Merged Document Report

Application No.: PL8935

PLAT OF **BLUFF PORTION** BLOCK 3, LOTS 1R & 2R

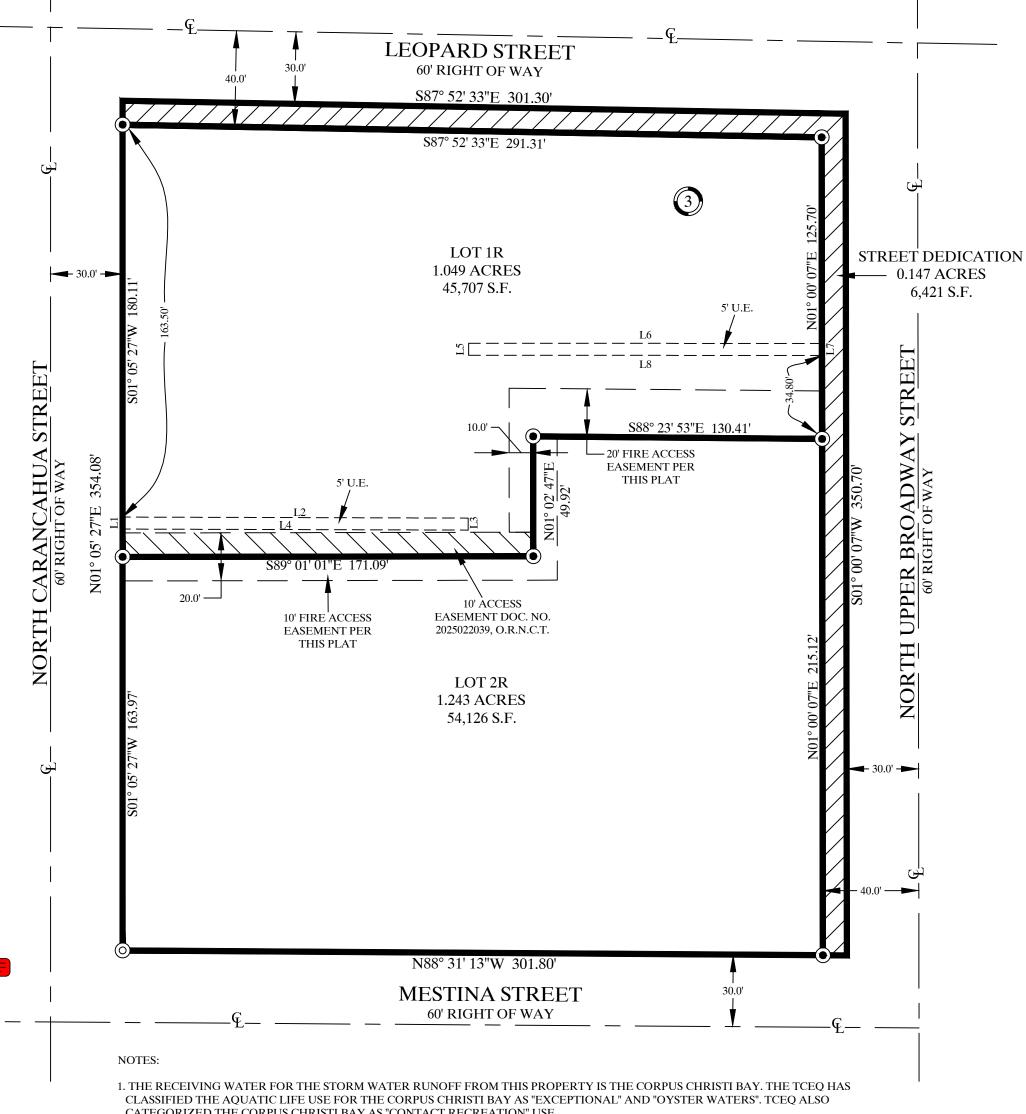
7	P001	Note	Mark Zans : LD	Closed	Fire comments #1 1 Plat Note: All code reference is based on currently adopted International Fire Code (IFC)

2021 and Corpus Christil Water Distribution Standards. 2019a10Lot 18 currently has the 3 sections of the high rise Wilson Plaza. Lot 28 had the large parking garage that was demolished. Due this being a high rise, Fire will need a 20 ft. access will allow our largest units tadder 11 or access will allow our largest units tadder 11 or access will allow our largest units tadder 11 or access will allow our largest units tadder 11 or access will allow our largest units tadder 11 or access will allow our largest units tadder 11 or access will allow our largest units tadder 11 or access will allow our largest units tadder 11 or access will allow our largest units tadder 11 or access will allow our largest units tadder 12 or access will allow our largest units tadder 12 or access will allow our largest units tadder 12 or access will allow our largest units tadder 12 or access will allow our largest units tadder 12 or access will allow our largest will be provided with approved on-site hydrants and water mains capable of supplying the fire flow require by the fire official. 1 me minimum arrangement being so as to have a hydrant available for distribution of hose to any portion of building on the premises at distances not exceeding 300 and outsire the second of the second or exceeding 300 and outsire the second or or access to fire hydrants shall be maintained at all times. The fire department shall not borstured access to fire hydrants shall be maintained at all times. The fire department shall not cross an arterial street. Gillinfo:1912.2, a gamendment proximity to Hydrant. Fire department connections (FDC) for each sprinker system or standards. Note: Hose lay from a hydrant will not cross an arterial street. Gillinfo:1912.2, a gamendment proximity to Hydrant. Fire department connections (FDC) for each sprinker system or standards street. Gillinfo:1912.1, a fire department connections (FDC) for each sprinker system or standards access road shall be provided for every facility, building, and facilities: Approved fire a	Comment ID	Page Reference	Annotation Type	Author : Department	Status	Review Comments	Applicant Response Comments

construction or demolition sites. Vehicle access shall be provided to within 100 feet of temporary						Standards. 2DPlatDLot 1R currently has the 3 sections of the high rise Wilson Plaza. Lot 2R had the large parking garage that was demolished. Due this being a high rise, Fire will need a 20 ft. access road between these 2 lots. Perferably a 26 ft. access will allow our largest units Ladder 1 to access the south side of this high rise. See comments 12-19 below. 3DPlatD'Commercial Development shall have a fire flow of 1,500 GPM with 20 psi residual Fire hydrant every 300 feet and operational." 4DPlatD507.5.1 (amendment) Where Required: All premises, other than one-family detached dwellings, where buildings or portions of buildings are located more than 150 feet from a fire hydrant shall be provided with approved on-site hydrants and water mains capable of supplying the fire flow require by the fire official. The minimum arrangement being so as to have a hydrant available for distribution of hose to any portion of building on the premises at distances not exceeding 300 feet. 5DInfor.D507.5.4 Obstruction. Unobstructed access to fire hydrants shall be maintained at all times. The fire department shall not be deterred or hindered from gaining immediate access to fire protection equipment or fire hydrants. Note: Hose lay from a hydrant will not cross an arterial street. 6DInfor.D912.2.3 (amendment) Proximity to Hydrant: Fire department connections (FDC) for each sprinkler system or standpipe system shall be located not more than 100 feet from the nearest fire hydrant connected to an approved water source 7DInfor.D503.1.1 (amendment) Buildings and facilities: Approved fire apparatus access roads shall be provided for every facility, building, or portion of a building hereafter constructed or moved into or within the jurisdiction. The fire apparatus access road shall allow access to three (3) sides of buildings in excess of fifteen thousand (15,000) square feet and all sides for buildings in excess for firefighting shall be provided to all construction or demolition sites. Vehicle access

8	P001	Note	Mark Zans : LD	Closed	Fire comments #2 11□Infor.□Note: An accessible road and a suitable water supply is required once construction materials are brought on site. 12□Infor.□503.2.1 Dimensions. Fire apparatus access roads shall have an unobstructed width of not less than 20 feet, exclusive of shoulders and an unobstructed vertical clearance of not less than 13 feet 6 inches. 13□Infor.□D103.1 Access road width with a hydrant. Where a fire hydrant is located on a fire apparatus access road, the minimum road width shall be 26 feet, exclusive of shoulders. 14□Infor.□"The minimum required width of 20 feet that shall be maintained means a clear unobstructed path that allows the passage of fire apparatus. 1.□Where Fire Apparatus Access is constructed to the minimum of 20 feet, no parking is allowed within the fire apparatus lane. 2.□Where a fire hydrant is located on the street, the minimum unobstructed clearance shall be 26 feet. In this instance, no parking is allowed on one side of the street. 3.□The minimum UDC residential street width is 28 ft. curb to curb. Any parking along the street that reduces the width to less than 20 ft. is prohibited and the Fire Code Official and will require painting

10	P001	Note	Mark Zans : LD	Closed	Fire comments #3 21 Infor. I503.3 Marking: Where required by the fire code official, approved signs, or other approved notices the include the words NO PARKING-FIRE LANE shall be provided for fire apparatus access roads to identify such roads to prohibit the obstruction thereof. The designation of a fire lane can be marked with conspicuous signs which have the words:" Fire Lane-No Parking" at 50-foot intervals. In lieu of signs, fire lanes may be marked along curbing with the wording, "Fire Lane-No Parking" at 15-foot intervals.

Comment ID	Page Reference	Annotation Type	Author : Department	Status	Review Comments	Applicant Response Comments
					22 Infor. Table D103.4 Requirements for Deadend fire apparatus access roads. Turnaround provisions shall be provided with a 96-foot diameter cul-de-sac. 23 Infor. 503.2.5 Dead ends. Dead-end fire apparatus access roads more than 150 feet in length shall be provided with an approved area for turning around fire apparatus. 24 Infor. D103.5 Fire apparatus access road gates. If installed-Gates securing the fire apparatus access roads shall comply with all the following criteria: Single gate width shall not be less than 20 feet. 12 feet gate width is required for a divided roadway. Electric gates shall be equipped with a means of opening the gate by fire department personnel for emergency access. Emergency opening devices shall be approved by the fire code official. Note: The use of a Knox Gate Switch is currently required by the Fire Official. Methods of locking shall be submitted for approval by the fire code official. Note: The Knox Padlock is currently required by the Fire Official. Electric gate operators, where provided, shall be listed in accordance with UL 325. Gates intended for automatic operation shall be designed, constructed, and installed to comply with the requirements of ASTM F 2200. 25 Plat Commercial development of the property will require further Development Services review.
